Final – Volume 3 of 4

Supplement to the Final Environmental Impact Statement Final Environmental Impact Report

Los Vaqueros Reservoir Expansion Project
California State Clearinghouse No. 2006012037

Figure 4-1. 2011 Estimated Daily Chinook Salmon Passage and Flow at Downstream Trapping Locations

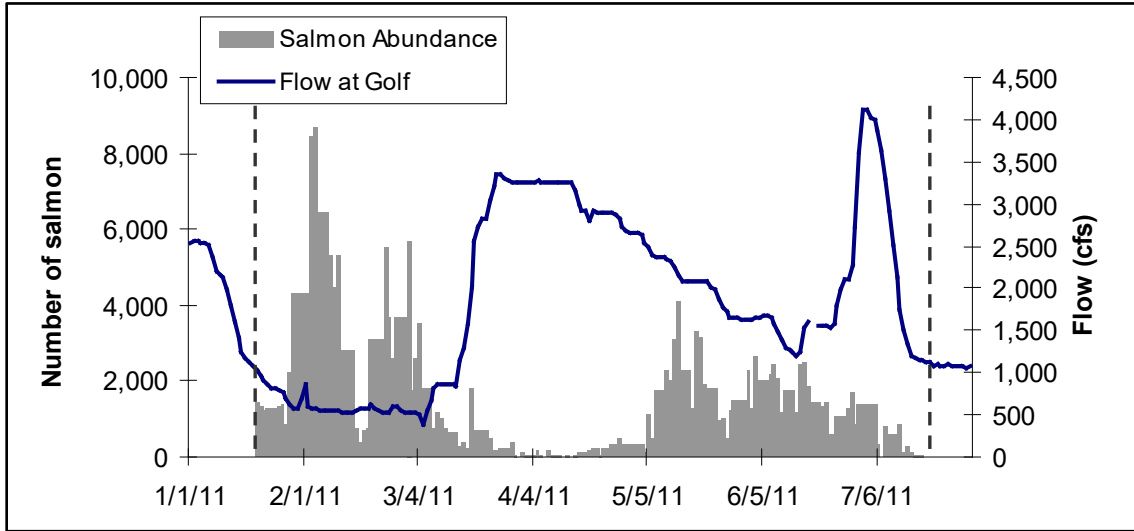
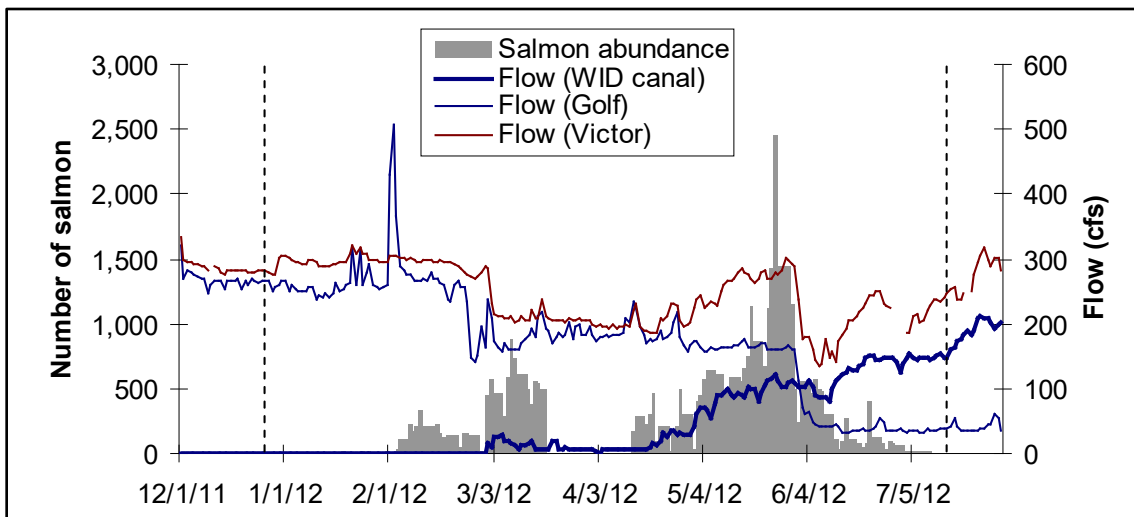
Figures 4-1 and 4-2 below are from 2011 (high flows early in season) and 2012 (low flows), respectively, and show the relationship between estimated daily Chinook salmon passage and flow at the downstream trapping locations during the juvenile outmigration monitoring season. The dashed vertical lines indicate the beginning and the end of the monitoring period. The data indicates that in 2011 a significant portion of the outmigrating Chinook salmon juveniles moved out as fry, while in 2012 the majority moved out as smolts. Although it is unclear if there are benefits to early fry outmigrations, the Phase 2 Expansion as proposed would not alter the number of years in which flows above 800 cfs occur.

Figure 4-3. Illustration of 190 ft msl threshold

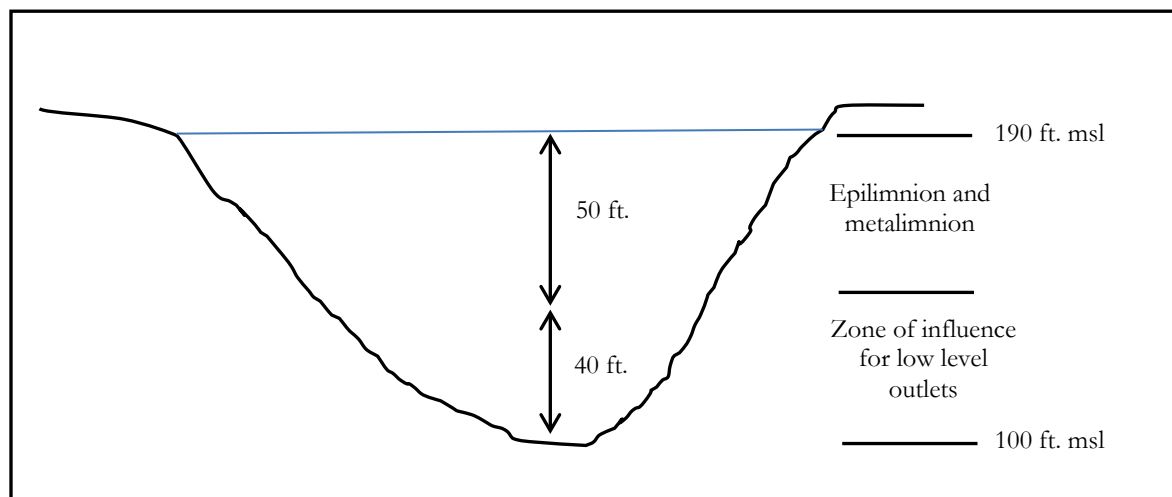
Figure 4-3 below illustrates how the 190 foot msl was developed. The zone of influence for Camanche’s low level outlets extends from the bottom of the reservoir up roughly 30 to 40 feet. The vertical extent of the epilimnion and metalimnion are driven by environmental factors and assumed to be fixed. Figure 3.4-5 in Appendix D-3 shows that the metalimnion extends down to about 50 feet below the surface elevation. The metalimnion will be drawn into the low level outlets whenever the bottom of the metalimnion drops down to within 40 feet from the bottom of the reservoir; therefore, the metalimnion is expected to begin to be drawn into the low level outlets if the water depth from the water surface to the bottom of the reservoir drops to 90 feet. The bottom elevation of Camanche Reservoir is 100 feet msl, so the threshold water surface elevation expected to result in the metalimnion waters entering the low level outlets is about 190 feet msl. If the surface elevation drops to below 190 feet msl, then warmer water from the metalimnion will be released downstream.

Figure 2-13
EBMUD-CCWD Intertie Pump Station

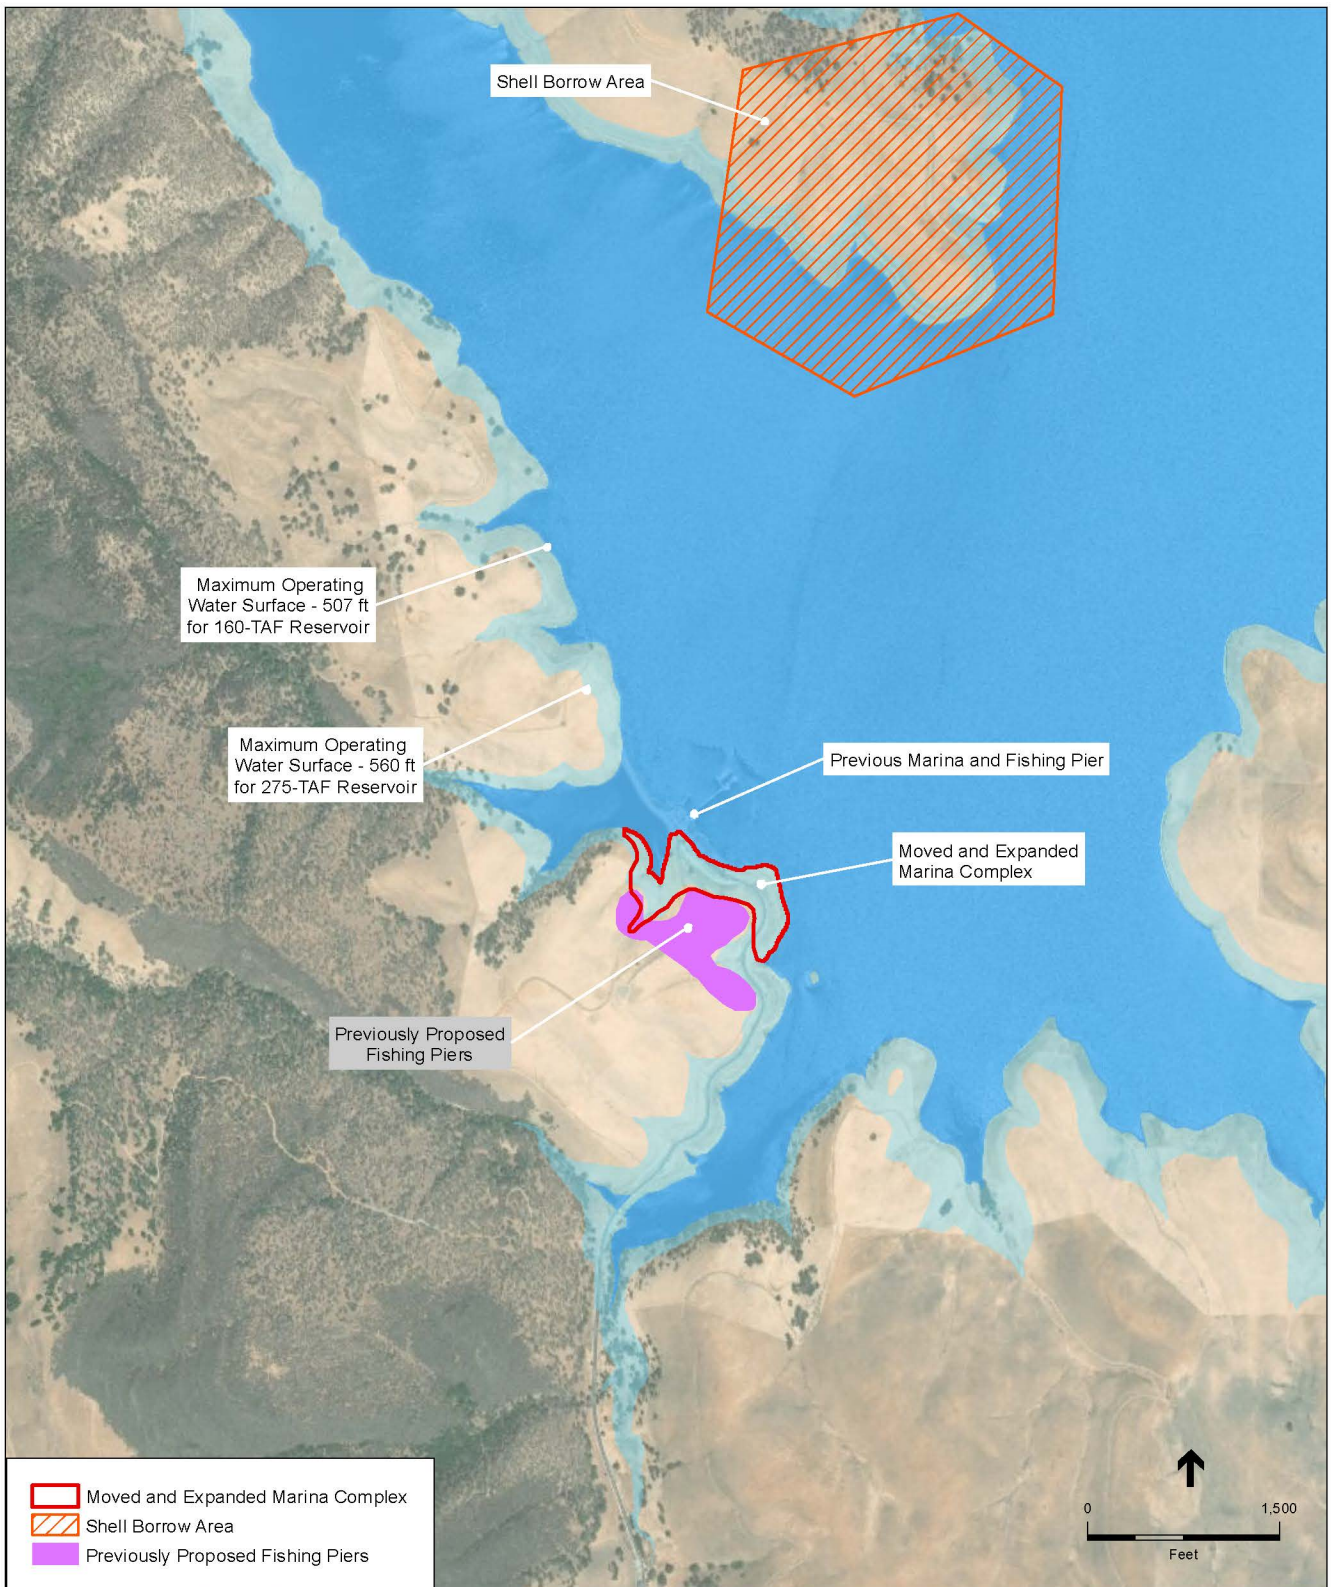
O_RTD_03 The commenter requests that Figure 2-13 be updated to show the Los Vaqueros Pipeline and Mokelumne Aqueduct in relation to the proposed EBMUD-CCWD intertie pump station.

The requested revision to Figure 2-13 has been made and an updated figure is provided in Chapter 5 of this Final Supplement.

Final Supplement Figure 2-13 shows the revised location of the proposed EBMUD-CCWD intertie pump station as described in Final Supplement Section 2.2.1, and shows the Los Vaqueros Pipeline and Mokelumne Aqueduct in relation to the proposed EBMUD-CCWD intertie pump station as described in response to comment O_RTD_03.

Los Vaqueros Reservoir Expansion Final Supplement to the Final EIS/EIR
Final Supplement Figure 4.12-1
 Potential Utility Crossings

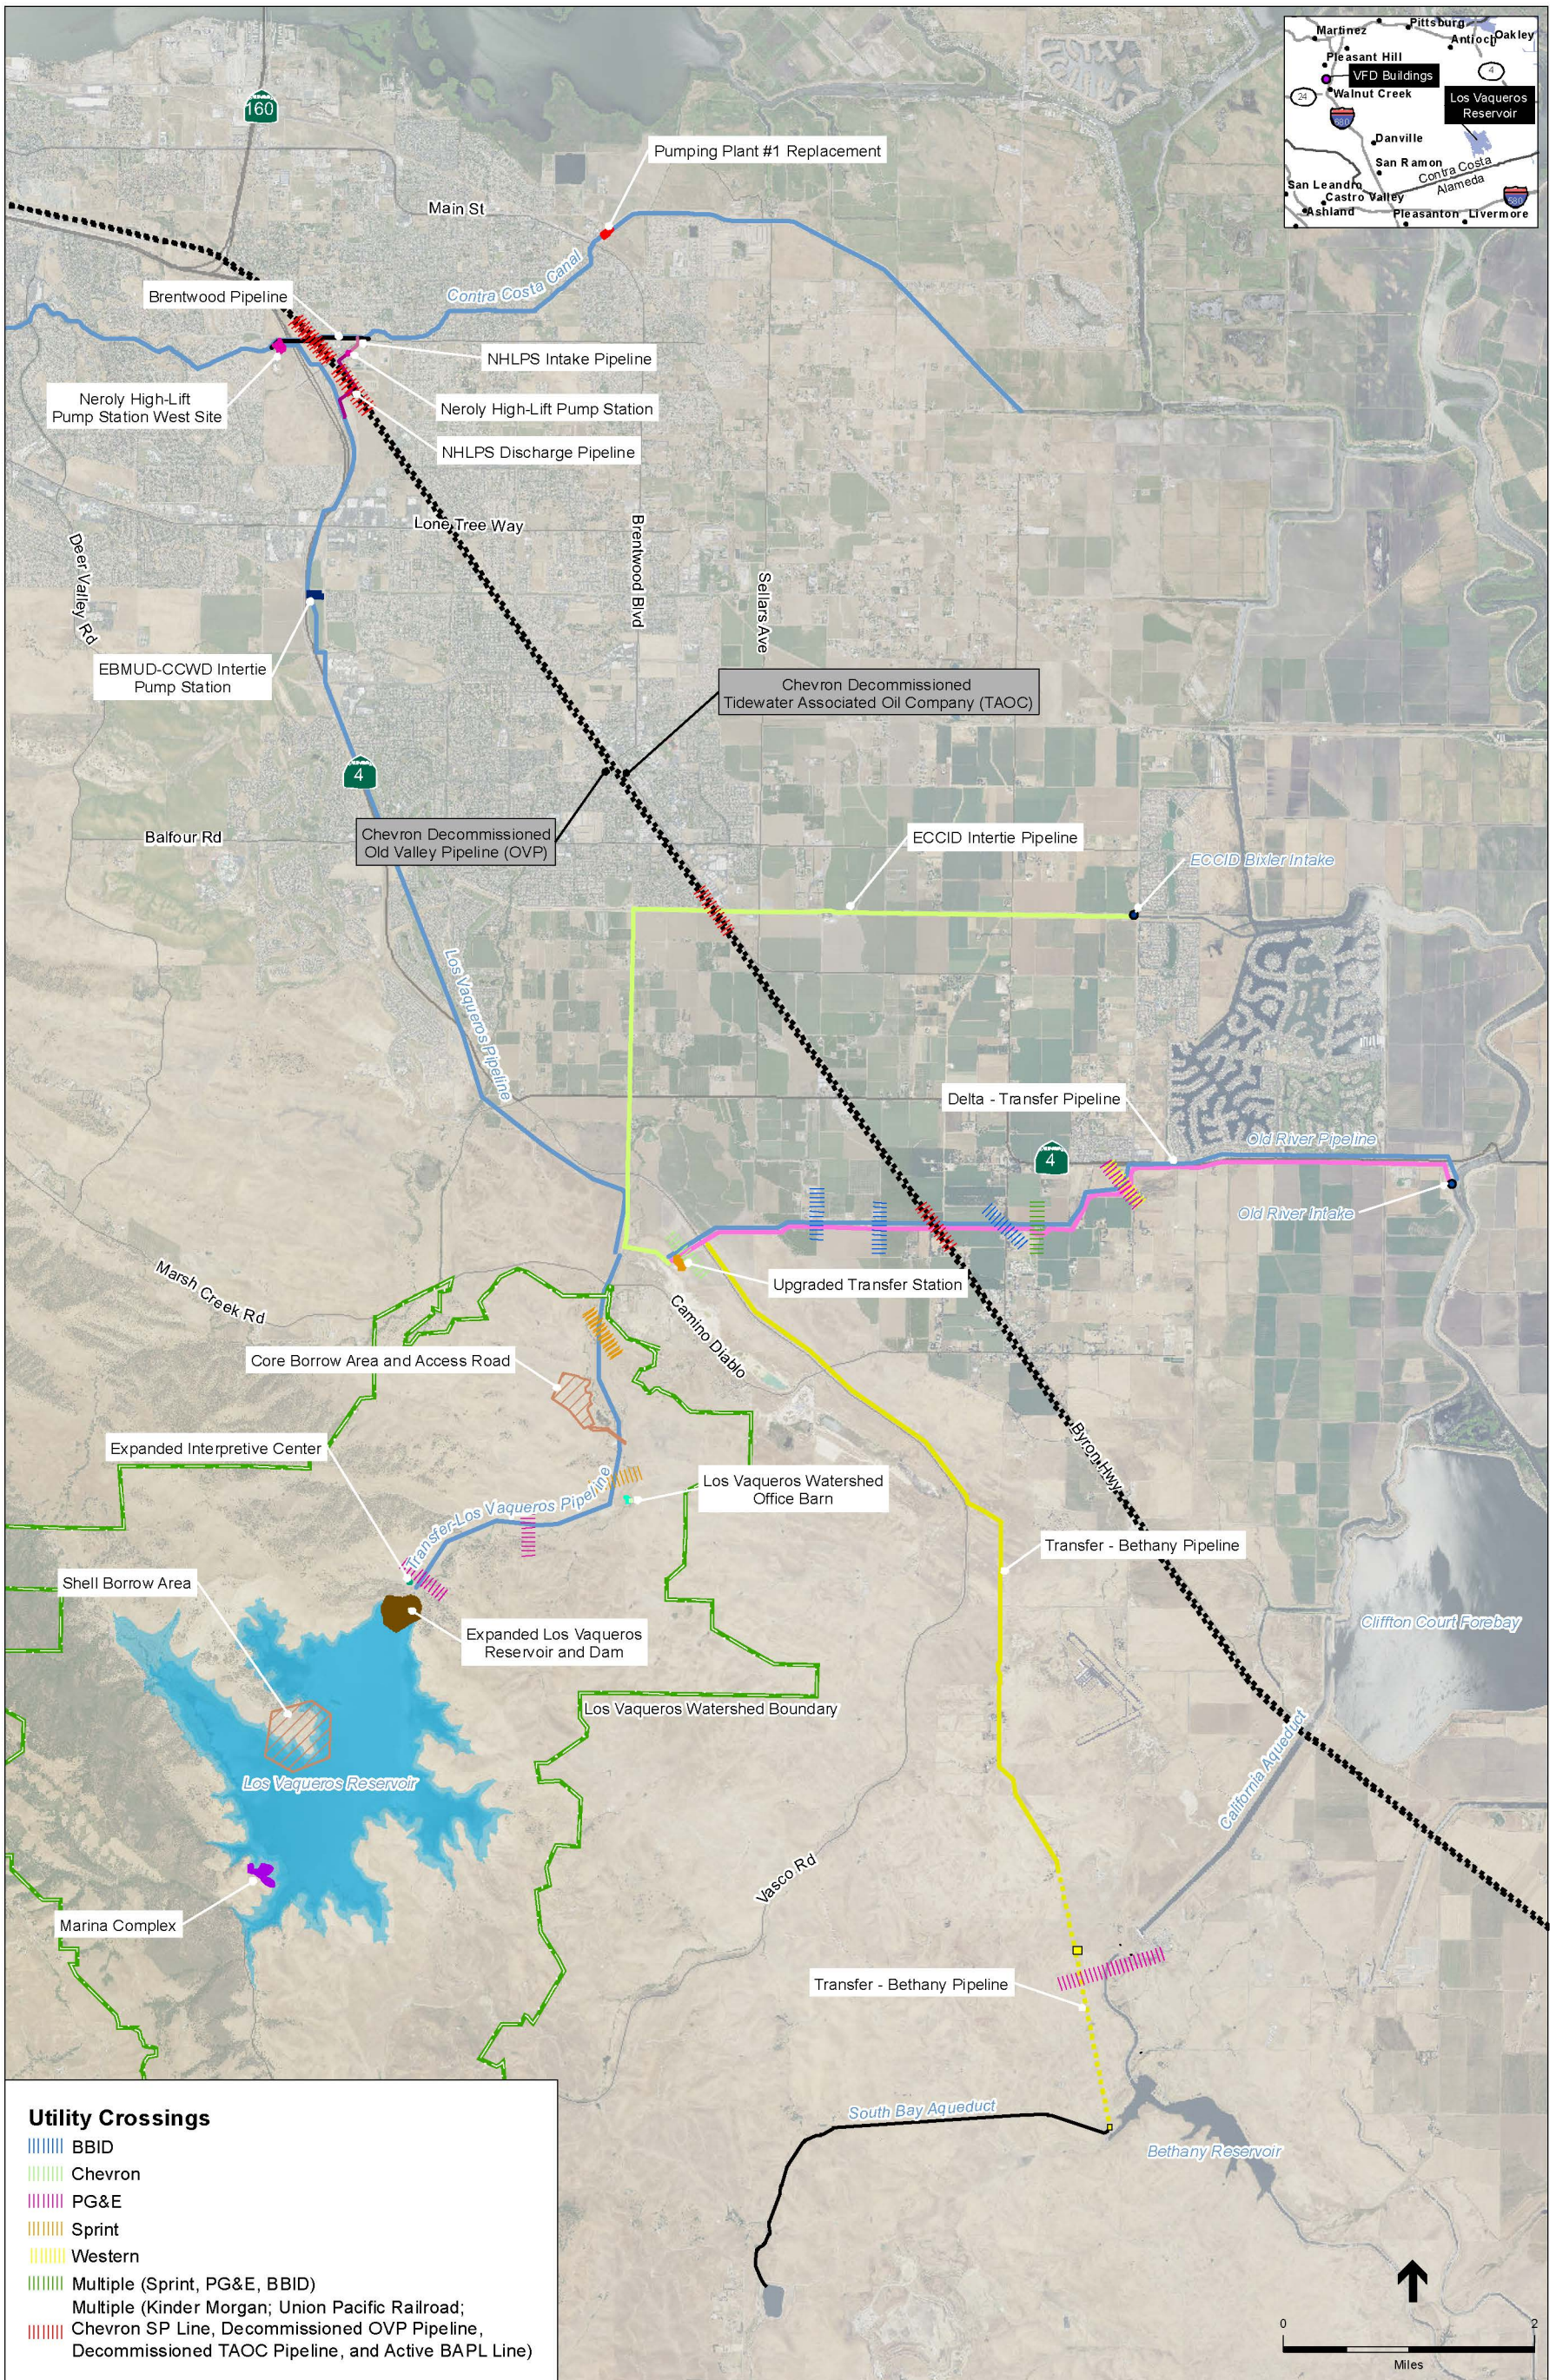
This is an extension of an issue that was raised by this commenter in 2010 and addressed the Response to Comments in **Final EIS/EIR Volume 4, Section 3.10.3, Chevron Facilities and Operation** (Chapter 3, p. 3-127 et seq.). At that time, CEMC identified, among other things, an intersection between the proposed Delta-Transfer Pipeline and two historical petroleum pipelines (Chevron’s double Tidewater Associated Oil Company Pipeline [TAOC] and Old Valley Pipeline [OVP]). This information was incorporated into the Final EIS/EIR, and reflected in Revised Draft EIS/EIR Figure 4.12-1 and the revised analysis in **Final EIS/EIR Volume 4, Section 4.12, Utilities and Public Service Systems** (p. 5.2-20 et seq.). The Draft Supplement relied on the information provided in the Final EIS/EIR. In its August 2017 letter on the Draft Supplement, the commenter identifies additional intersections of decommissioned Chevron pipeline rights-of-way

This Supplement has been revised to reflect these intersections in Final Supplement Figure 4.12-1. These intersections include:

1. OVP and TAOC with the Delta-Transfer Pipeline (also identified in Final EIS/EIR; see Final EIS/EIR Figure 4.12-1)
2. OVP and TAOC with the ECCID Intertie Pipeline
3. OVP and TAOC with the Neroly High-Lift Pump Station Discharge Pipeline
4. OVP and TAOC with the Brentwood Pipeline

Final Supplement Figure 4.12-1 depicts intersections of decommissioned Chevron pipeline rights-of-way with proposed pipeline elements of the Phase 2 Expansion Project as described in response to comment O_CEMC_01.
